**THIRD ADDENDUM TO INVITATION TO BID
FOR THE DURHAM WRRF ODOR CONTROL PHASE 3 HEADWORKS
PROJECT NO. 7202**

CLEAN WATER SERVICES

ISSUED: APRIL 20, 2026

Jacobs
DWG #:
200-S-331

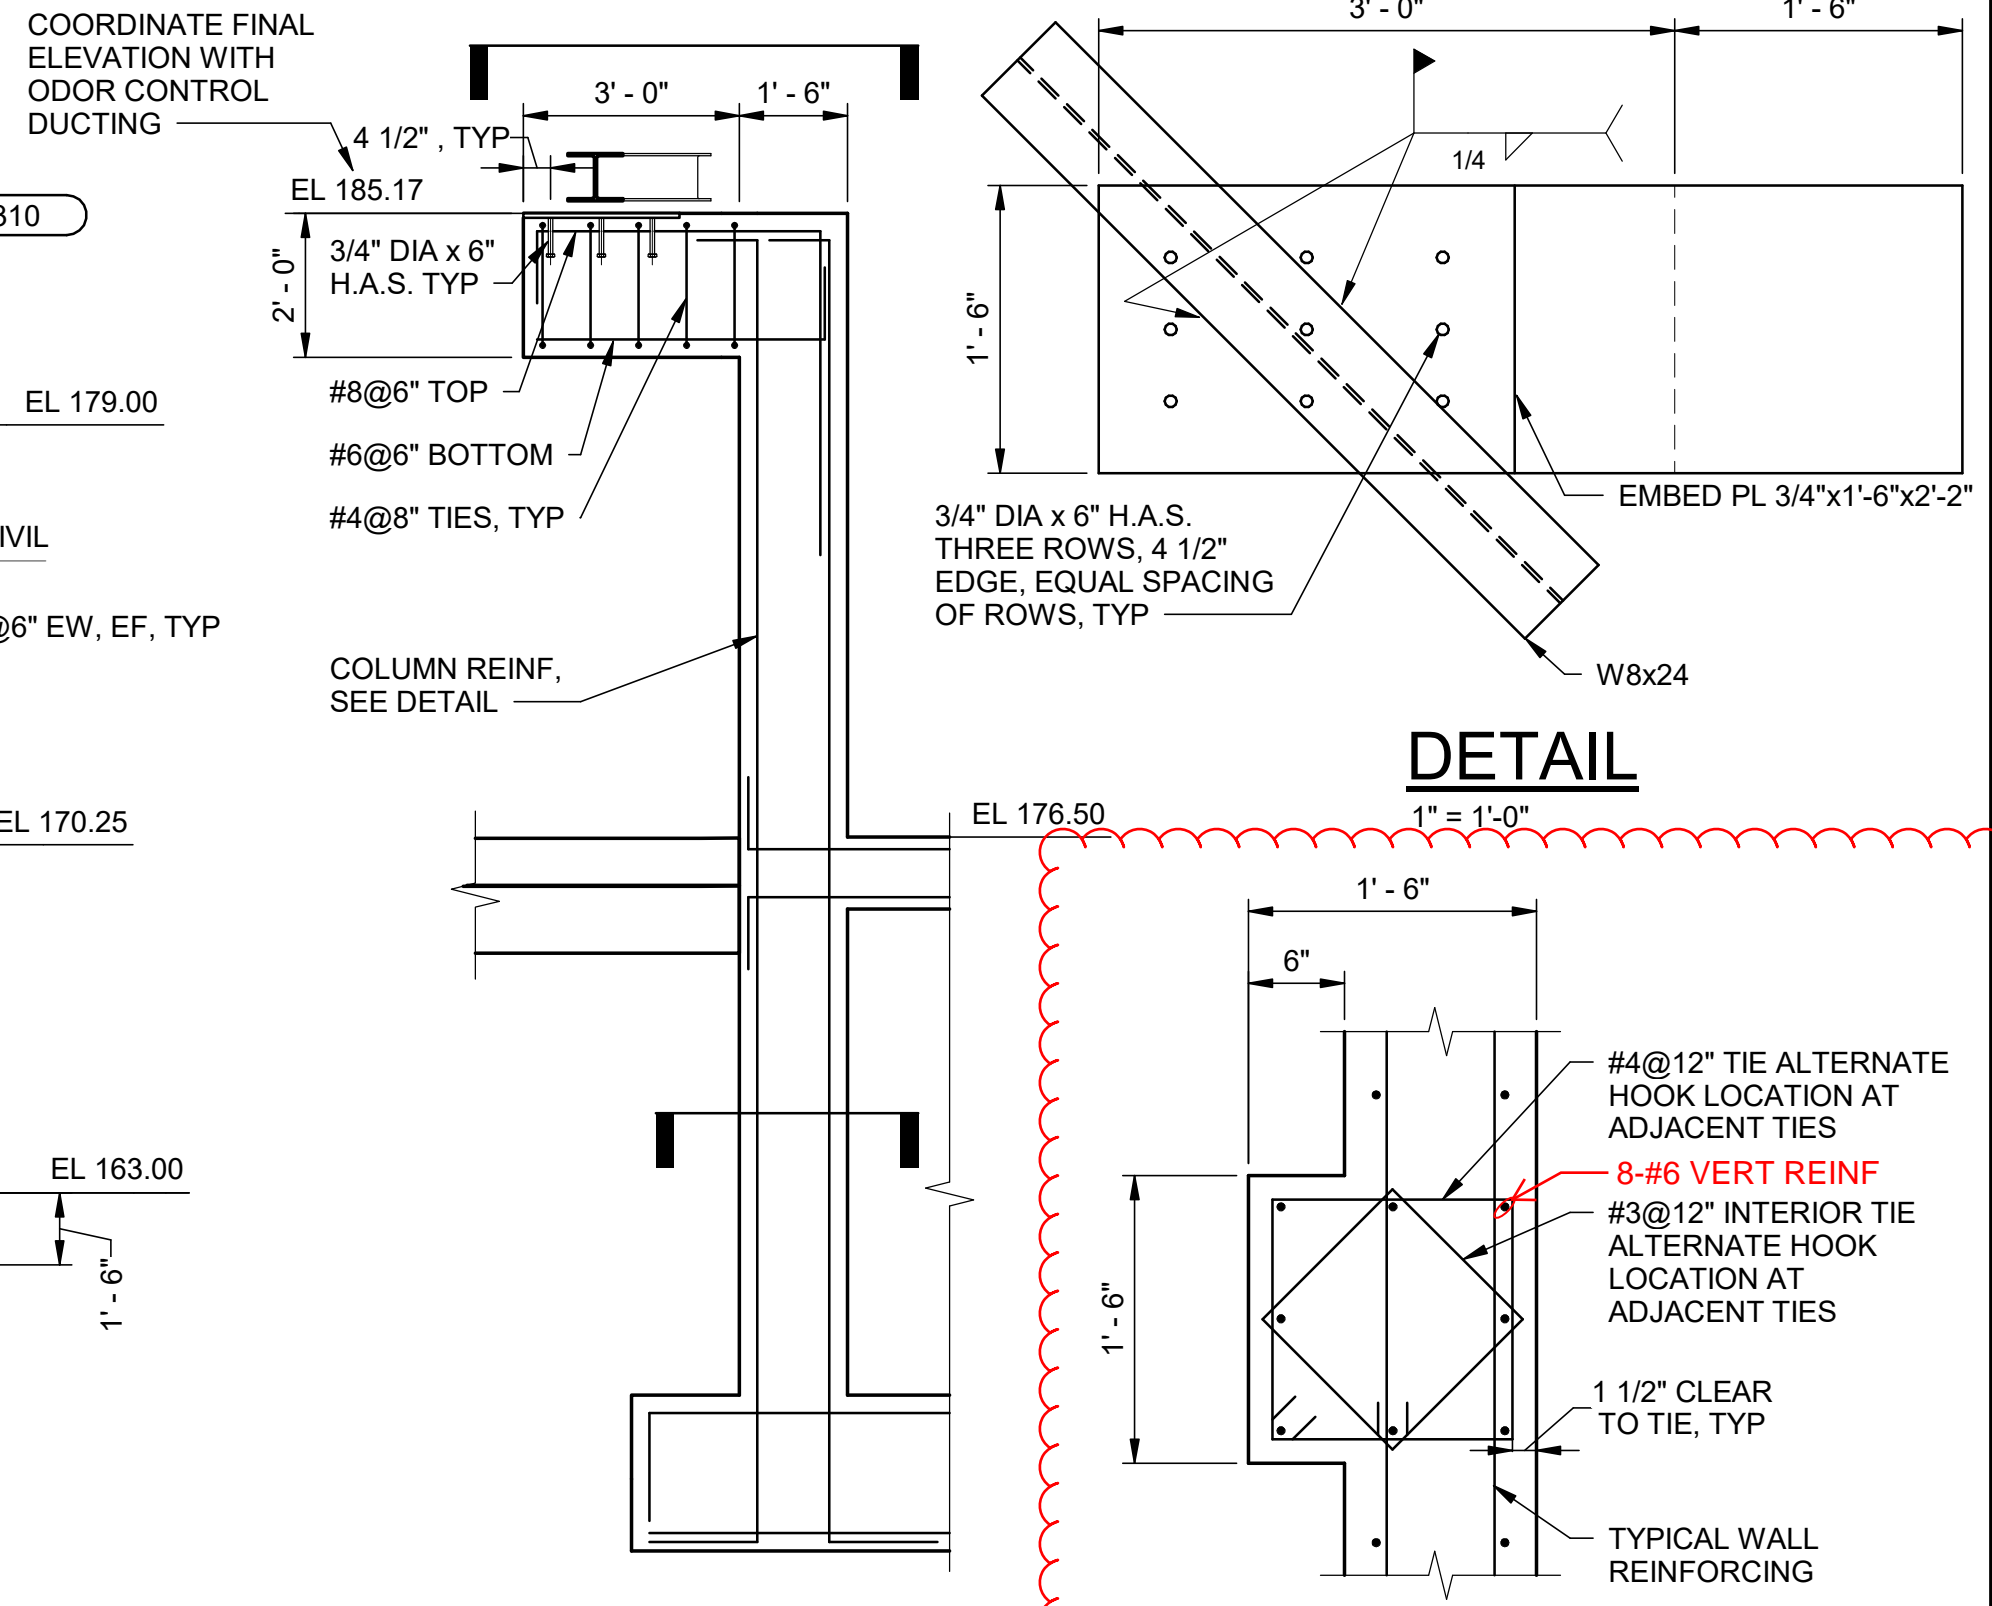
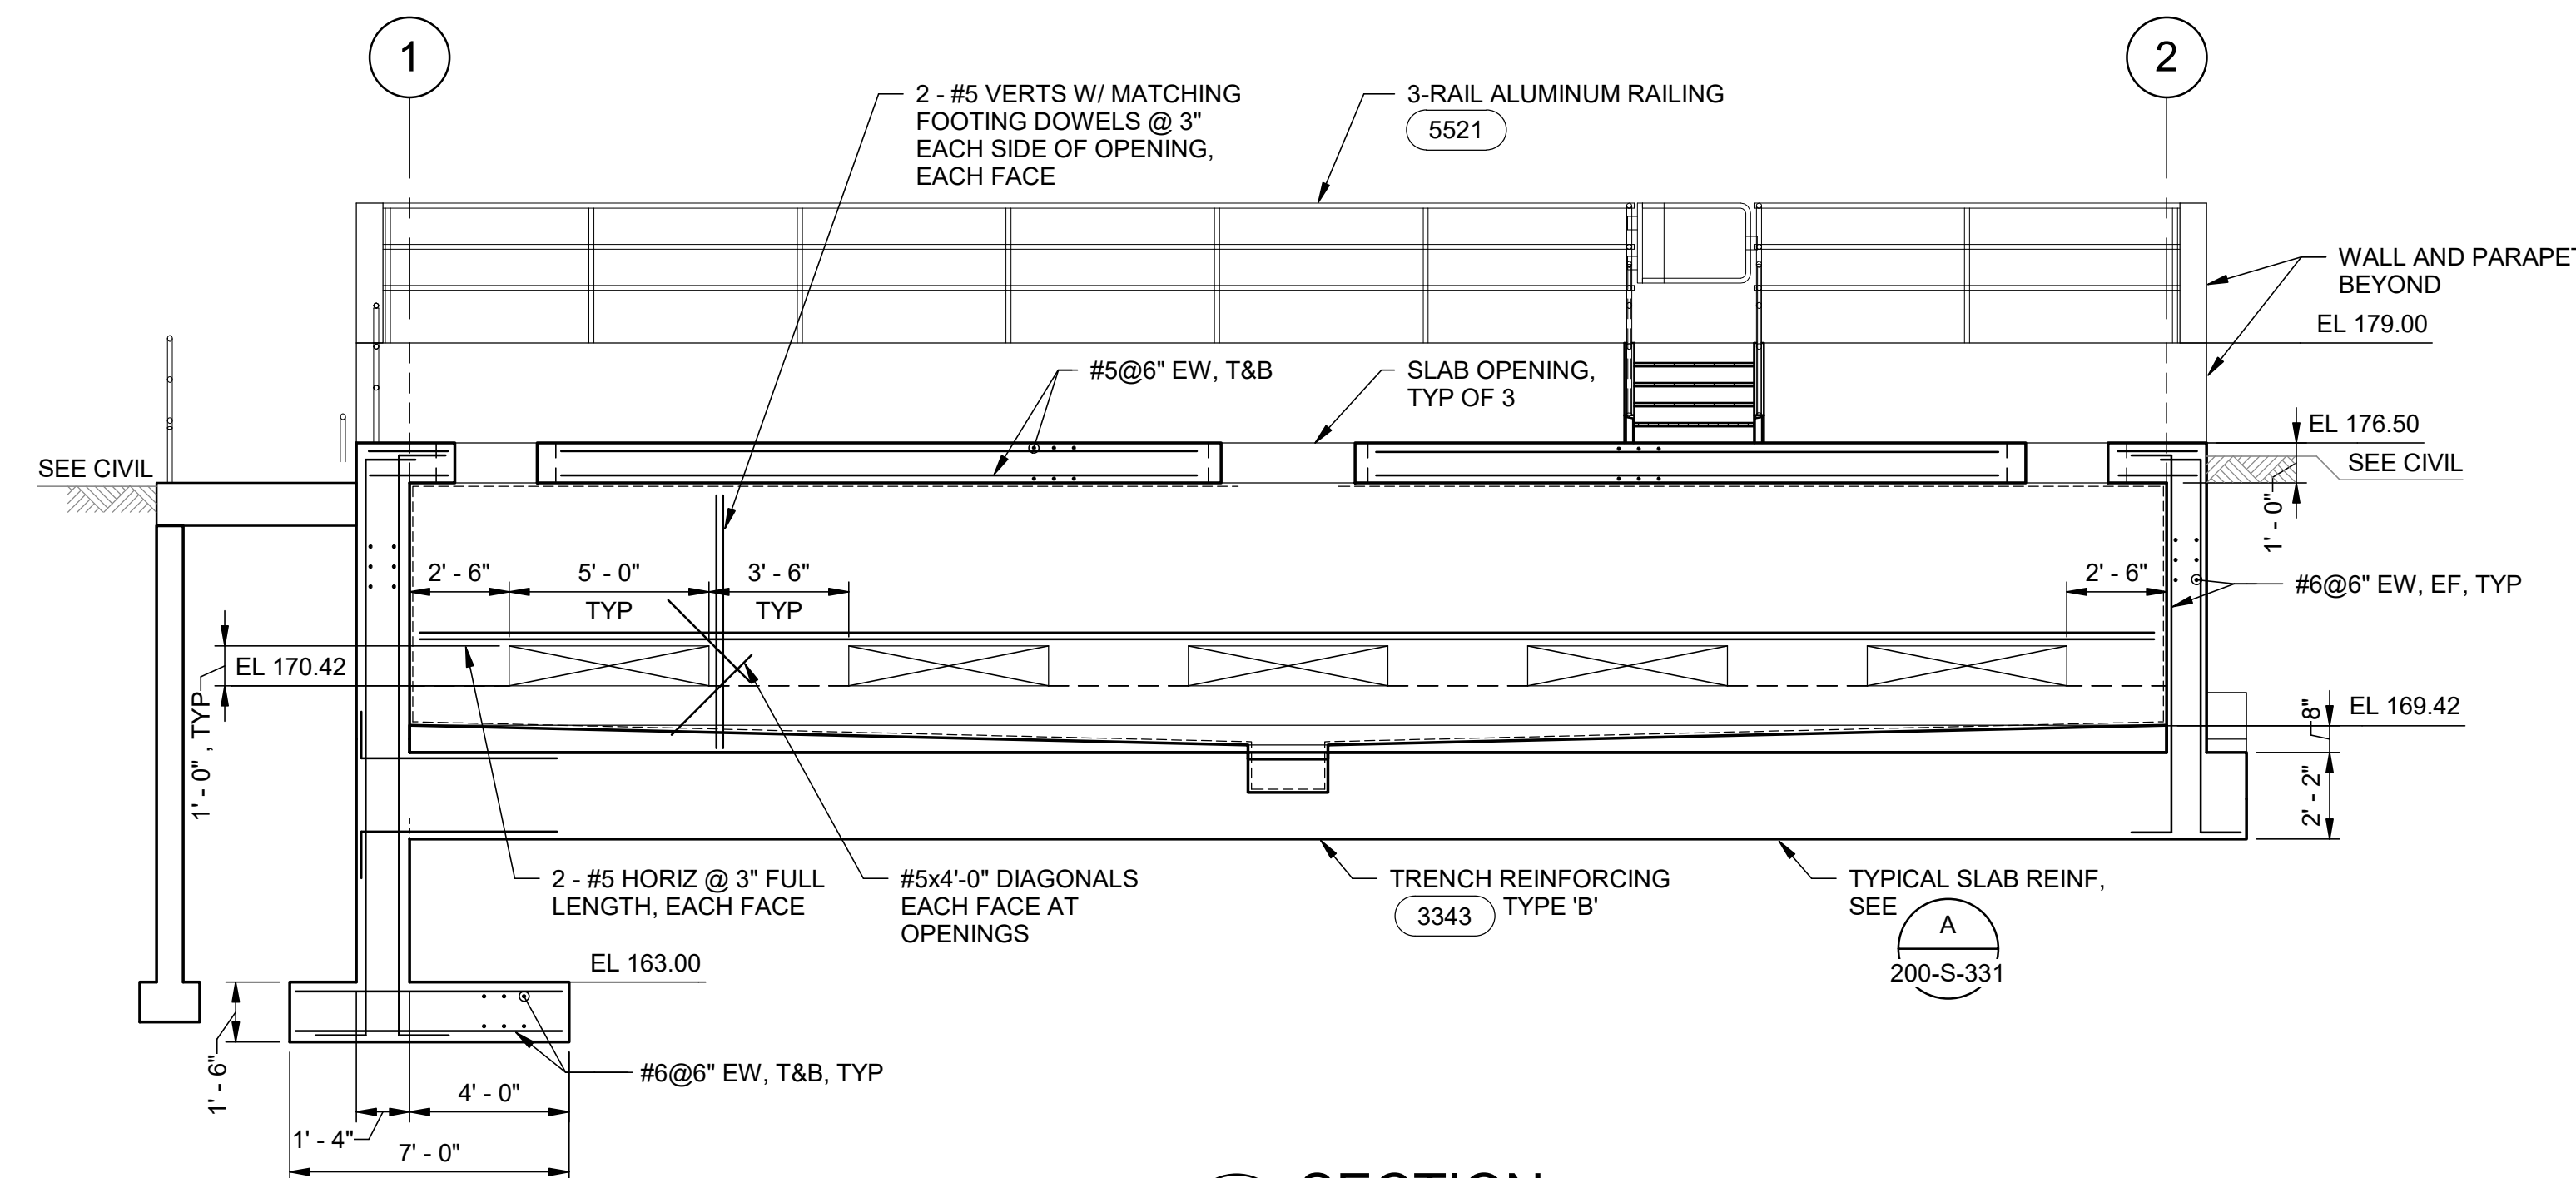
- c. Delete the following Drawings and replace them with the Drawings included in Exhibit A of this Addendum:

1. 200-S-331
2. 200-S-333
